Amendments to the Drawings:

REMARKS

FIG. 8

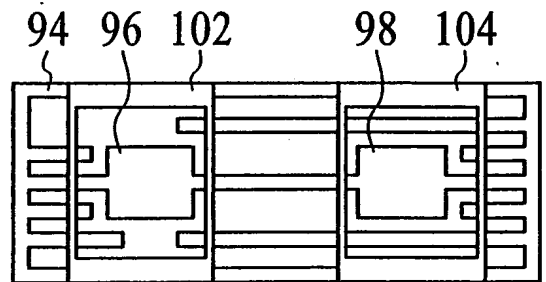
Support for the amendment may be found in Fig. 14 and its related text. Figs. 8 and 10 also show the locking mechanism, but less clearly. In the embodiment of Fig. 14, the locking mechanism is shown as a hook-shaped extension (106) from a first portion (102) of a package body, with the hook-shaped extension being configured to fit within an opening of the second portion (104). As further supported by the application as originally filed, other locking mechanisms may be provided which would fit within the scope of amended claim 21.
